# United States Patent and Trademark Office

APPLICATION NO.	FILING DATE	FIRST NAMED INVENTOR	ATTORNEY DOCKET NO.	CONFIRMATION NO.
10/750,380	12/29/2003	Jeffrey S. Hovland	2316.1646US01	4932
7590 05/15/2006			EXAMINER	
Merchant & Gould P.C.			ROJAS, OMAR R	
P.O. Box 2903 Minneapolis, MN 55402-0903		ART UNIT	PAPER NUMBER	
			2874	
			DATE MAILED: 05/15/2006

### **DETAILED ACTION**

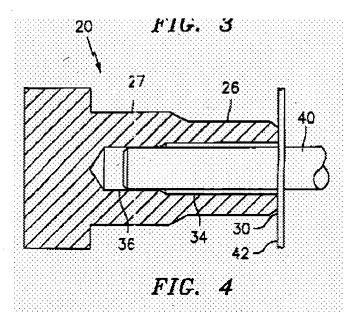
Regarding claims 16, 23, and 24, Ott discloses a fiber optic connector assembly (e.g., Fig. 4) comprising:

a fiber optic connector 42 mounted to an end of and terminating a fiber optic cable and a ferrule 40 holding an optical fiber from the cable, the ferrule including a end face;

a plug/dust cap 20 configured to fit about and engage the ferrule 40 of the fiber optic connector, the dust cap 20 positioned about and engaging the ferrule to seal the end face from air-borne particles. Figure 4 of Ott is reproduced below.

Regarding claim 26, the shoulder 25 of Ott corresponds to the recited finger hold.

Thus, Ott only differs from claims 16, 23, 24, and 26 in that Ott does not teach an adhesive tape/cover for holding the dust cap 20 to the connector 42, a center portion of the adhesive tape releasably attached to the dust cap 20 and first and second end portions of the adhesive tape releasably attached to the fiber optic connector 42.

In view of the Ott invention, one of ordinary skill in the art would have wanted to use releasable adhesive tape in order to provide additional securement of the dust cap 20 to the connector 42, i.e., by "sticking" them together. Wrapping the adhesive tape in the manner prescribed by claim 24 would be a simple and obvious method of better securing the dust cap 20 to the connector 42 in Ott using adhesive tape.

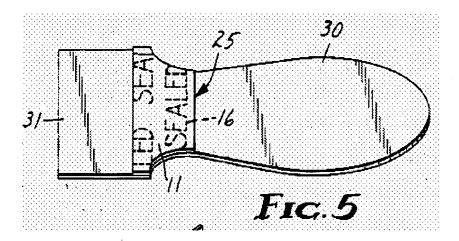
Regarding claims 25 and 27, the previous remarks above concerning Ott are incorporated herein. The invention of claims 23 and 24 has been shown to be obvious in view of Ott. Ott further differs from claims 25 and 27 in that Ott does not disclose tape having an anti-tamper feature or tape having a tail to facilitate removal as recited by claims 25 and 27, respectively. Schaefer, on the other hand, discloses an adhesive tape 25/30 having an anti-tamper feature 11/16 and a tail 31 to facilitate removal. See column 4, lines 7-28 of Schaefer. Fig. 5 of Schaefer is reproduced below.

One motivation for combining Schaefer with Ott is to provide an anti-tamper mechanism for Ott's dust cap 20. For example, if a small child were to gain access to the dust cap 20 of Ott, the child could pull off the dust cap from the ferrule 40 possibly exposing the ferrule end face to contaminants. By combining the anti-tamper adhesive tape 25/30 of Schaefer with Ott, such antics could be prevented. Therefore, it would have been obvious to one of ordinary skill at the time of the claimed invention to obtain the invention specified by claims 25 and 27 in view of Ott combined with Schaefer.
